**DWR EXHIBIT G**  
Application, File No. 45,572

### APPLICATION FOR PERMIT TO APPROPRIATE WATER FOR BENEFICIAL USE

ASR Project DW-1

CITY OF WICHITA  
PRELIMINARY DESIGN  
DIVERSION WELL  
DW-01

**Figure 1. - Equus Beds Groundwater Management District No. 2  
 Aquifer Storage and Recovery Project Map  
 July 13, 2004**

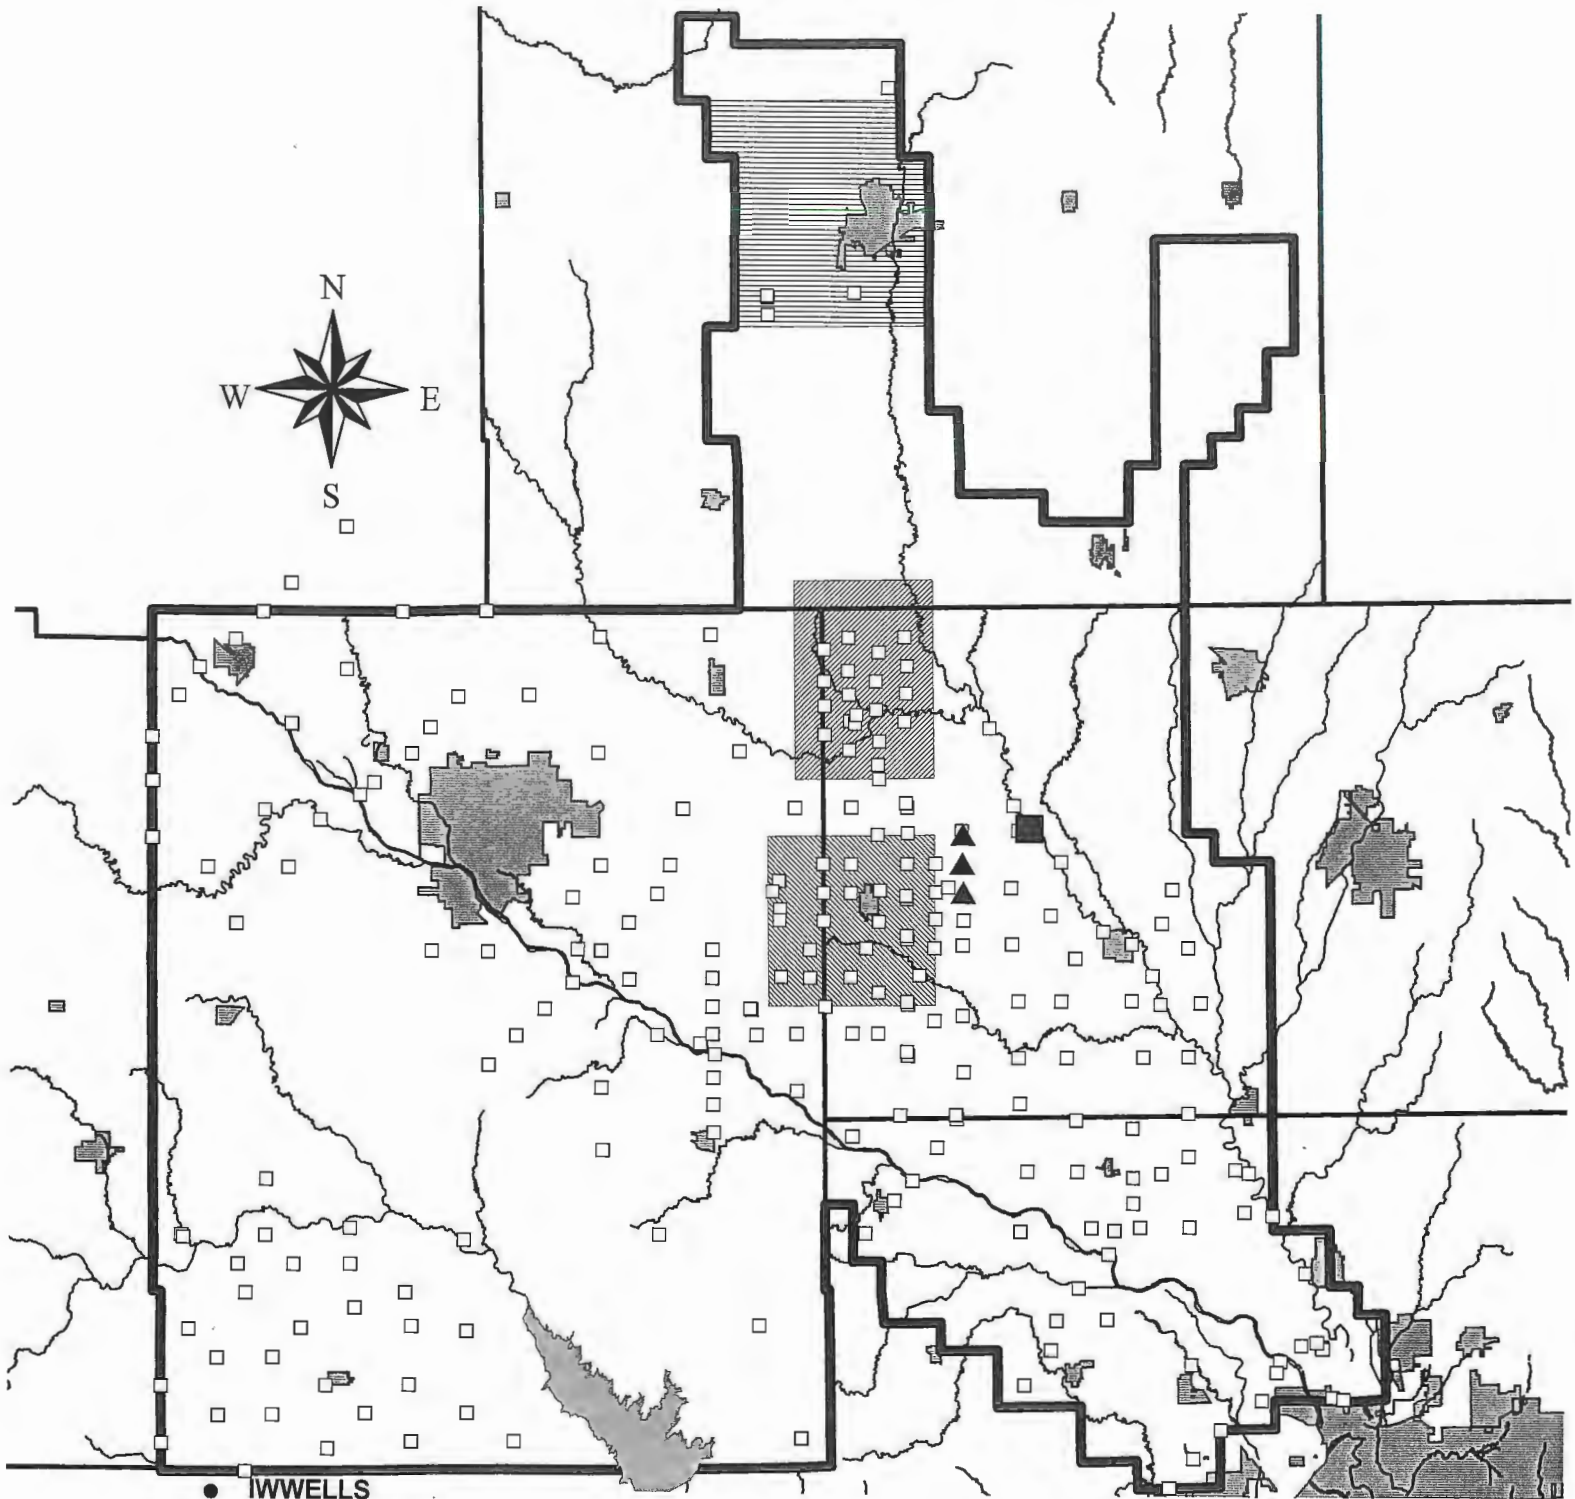
The proposed bank storage well shall be utilized only when river flow exceeds 42 cubic feet per second (cfs) from April through September, and 20 cfs from October through March, as measured at the United States Geological Survey (USGS) gage located at Highway 50 near Halstead (figure 1).

**Figure 2. – Application No. 45572 Site Map - SE 08-23S-2W**  
 Prepared by: Equus Beds Groundwater Management District No. 2 - 06/30/04

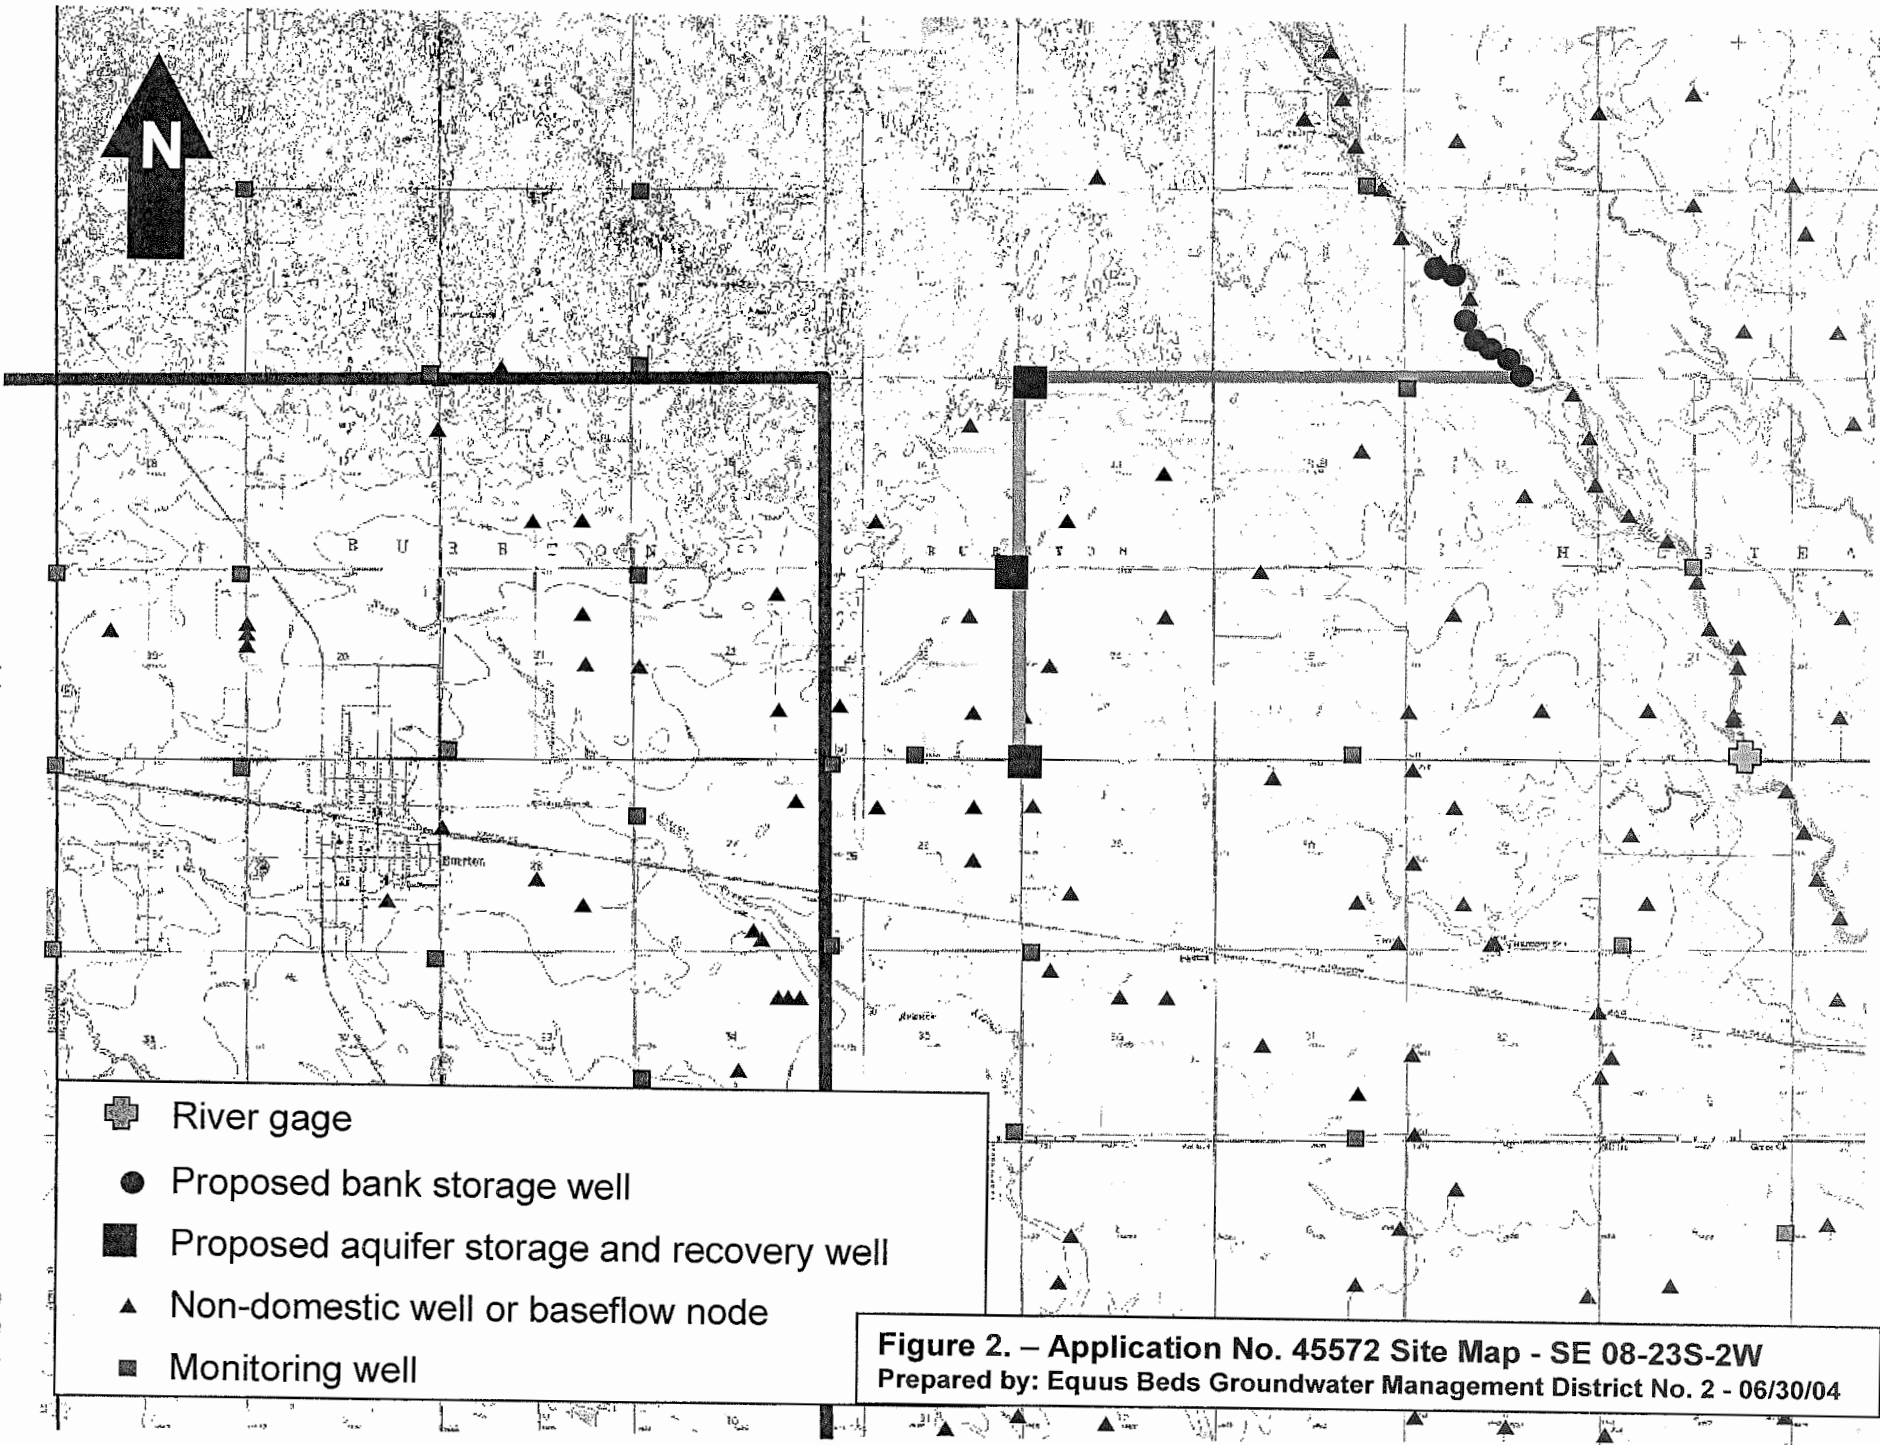
The proposed source water for the applicant's artificial recharge use in the aquifer storage and recovery system, is bank storage water to be diverted from a proposed well located in the SE-SW-SE of Section 8, Township 23 South, Range 2 West (figure 2).

Figure 4. – Application No. 45572 Lithologic Log and Construction Design for Bank Storage Well

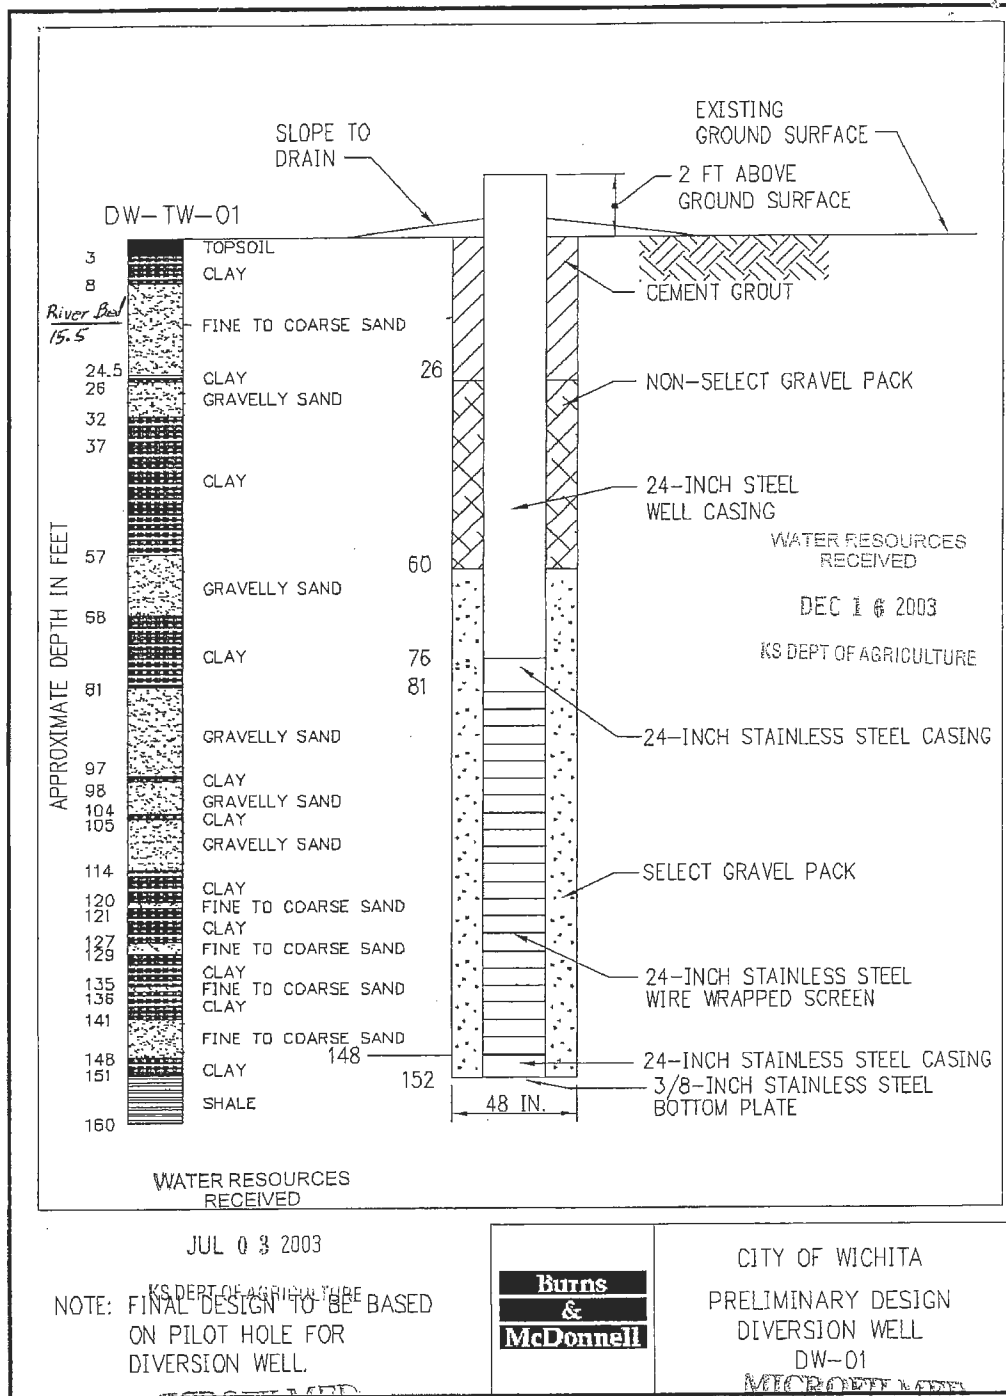
The lithologic log of the proposed well site indicates that the aquifer is comprised of alternating sand and clay layers, with shale encountered at 151 feet (figure 4). The log indicated that clay units exist at depth ranges of 32 to 57 feet bls, and 68 to 81 feet. The horizontal extent and continuity of the clay units were not determined. The lower portion of the aquifer was also predominantly clay with interbedded thin sand units throughout from 114 to 151 feet bls.

The application's proposed well depth is 148 feet bls (figure 4), with a proposed screen interval from 81 to 148 feet bls. The well is proposed to be screened in the lower portion of the aquifer below the clay unit located from 68 to 81 feet bls. The applicant proposes to utilize a 24-inch diameter well casing and screen.

Figure 5.

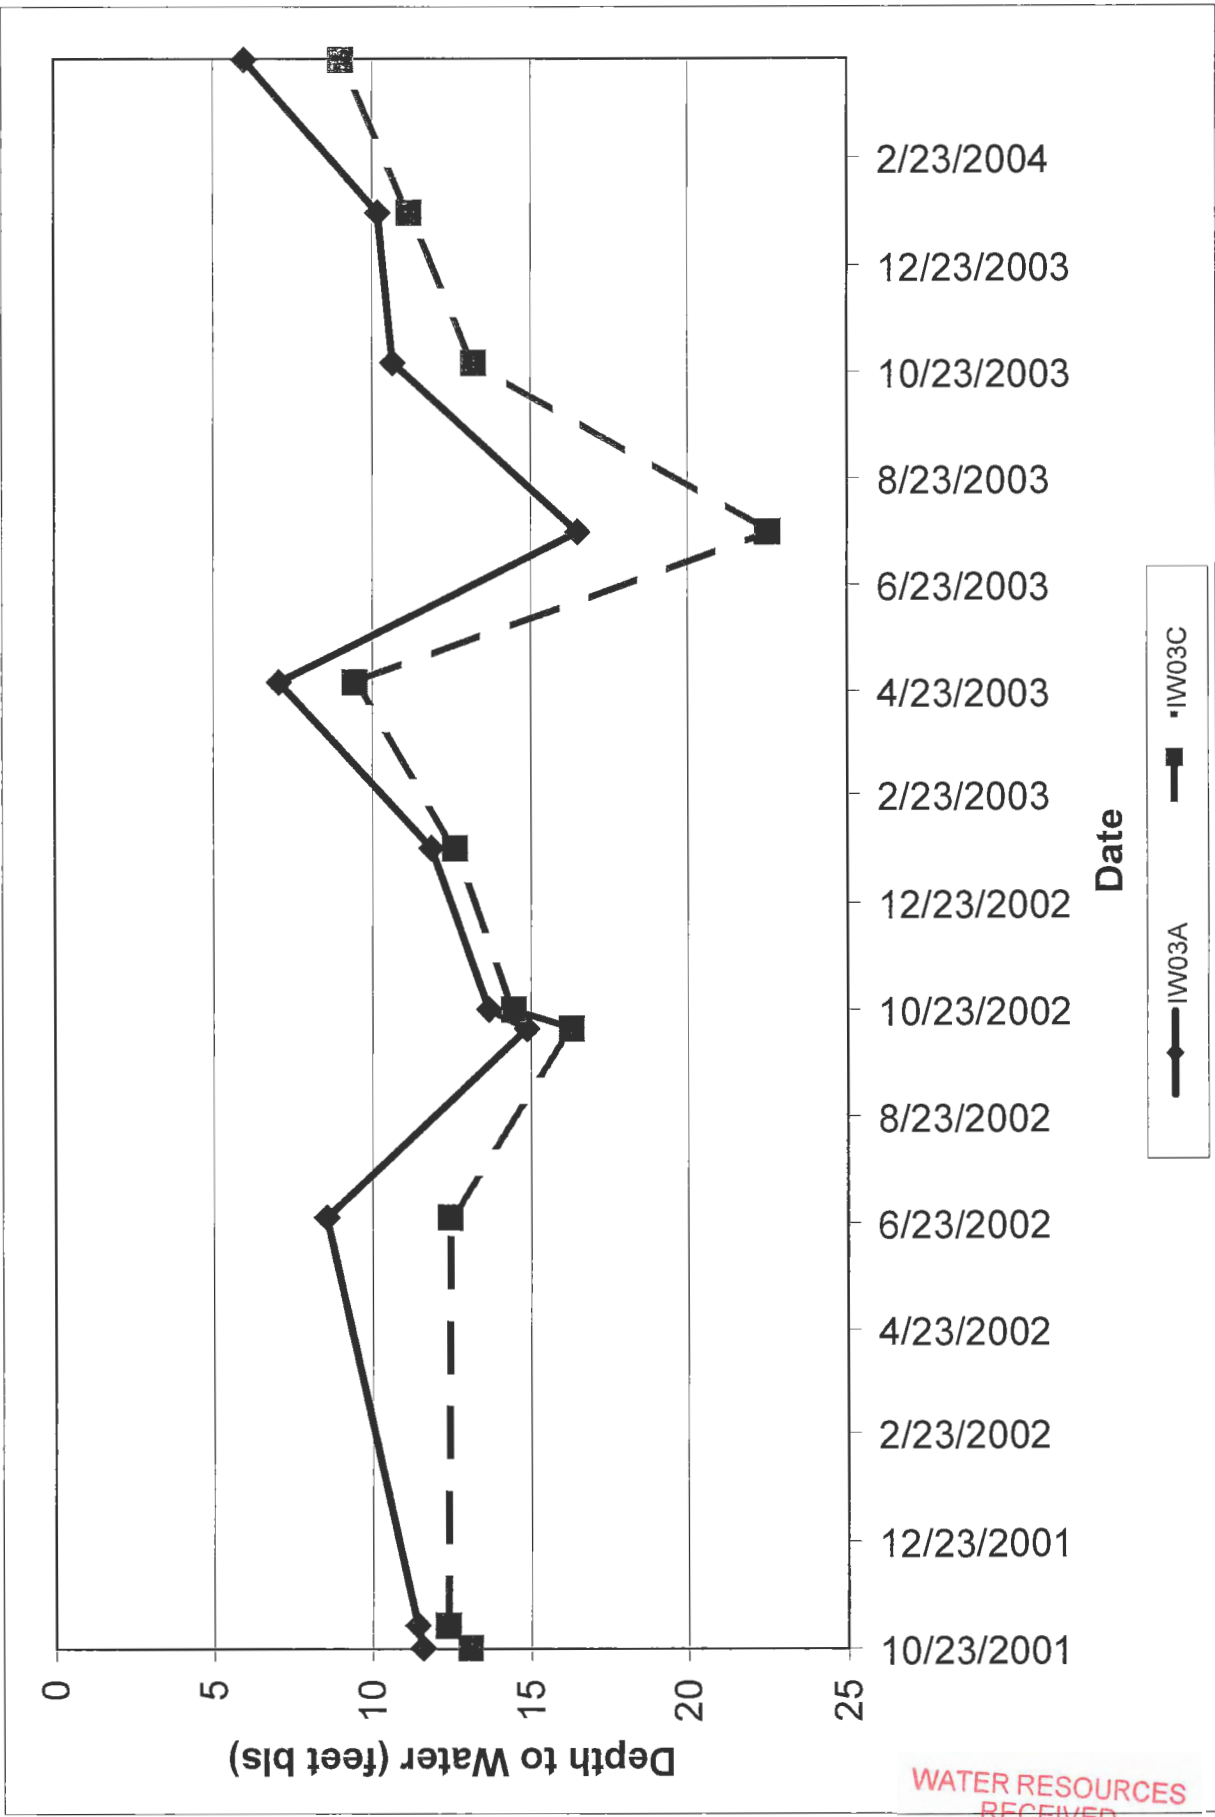
Water level data has been recorded by the District at groundwater monitoring site IW03 located approximately 0.6 mile west of the proposed well site (figure 3). Water levels recorded at the site during the period of record from October 2001 to April 2004 (figure 5), ranged from 5.99 to 16.49 feet bls in IW03A (total depth 34 feet), and from 9.03 to 22.53 feet bls in IW03C (total depth 138 feet). The IW03C lithologic log reported that depth to bedrock was 166 feet bls.

IW03 water level data (figure 5) indicated that a head difference ranging from approximately 1 to 6 feet existed between the upper zone (A well) and the lower zone (C well). The water levels in both zones exhibited similar responses to water table fluctuations, indicating a hydraulic connection. The fluctuation responses indicated leakage occurrence from the upper zone to the lower zone. Pumping effects exhibited in the lower zone also affected water levels in the upper zone. The correlation between the data sets indicated that the clay unit separating the two zones is not continuous throughout the area.
